JORDAN VALLEY WATER CONSERVANCY DISTRICT
11800 SOUTH U-111 PROJECT

NO.	DATE	DR	CHK	APVD
1		R. WILLEITNER	C. HOGGARD	N. JONES
1	02/10/2017	A2 - MODIFY PROFILE ON PRV VAULT

NO.	DATE	DR	CHK	REVISION	BY	APVD
1	01/27/2016	A1.14	REISSUE DRAWING			
2	02/08/2017	A2	ADJUST VIEW AND SHOW ELEC CONNECTION TO EXIST VAULT

RTU PEDESTAL AND FAN

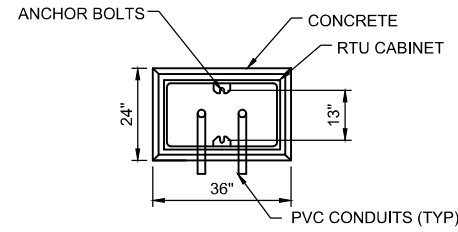
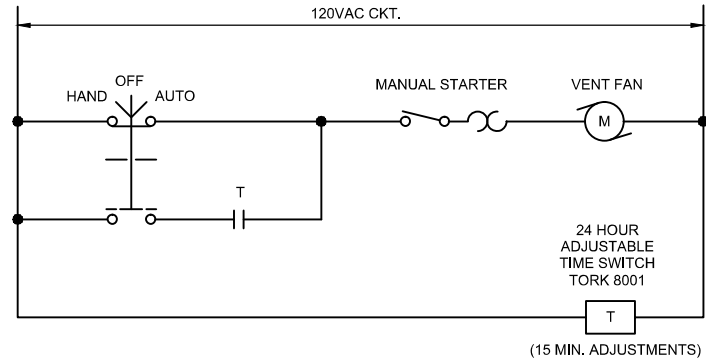
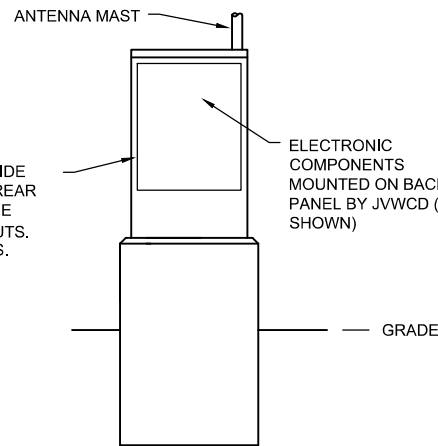
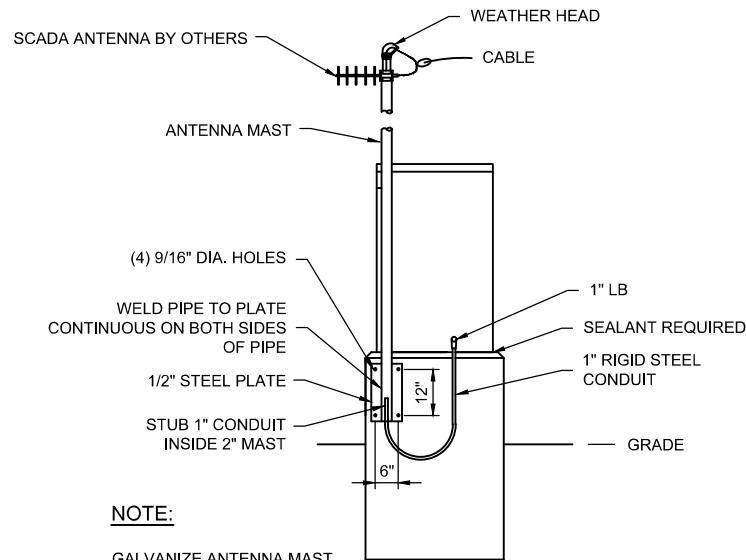
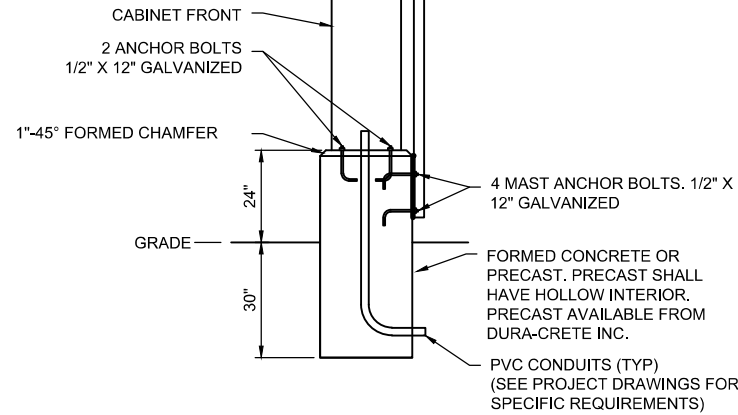
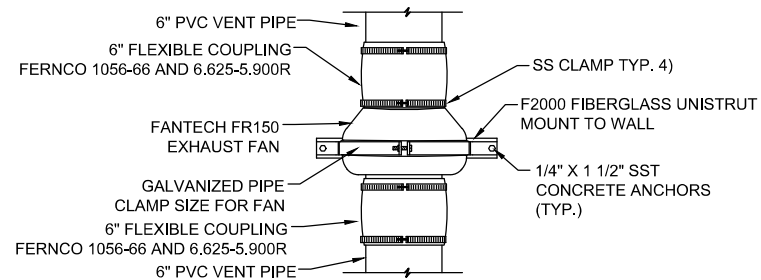
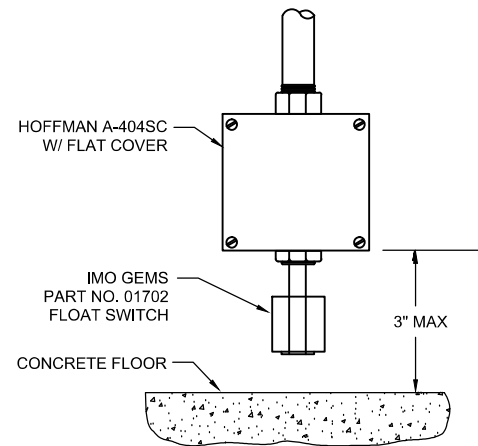
CH	CH	BY	APVD
			C WILLIAMS
NO.	DATE	DR	APVD
			C WILLIAMS
NO.	DATE	CHK	REVISION
			C HOGGARD
ISSUE NEW DRAWING			
1 02/08/2017 A2 -
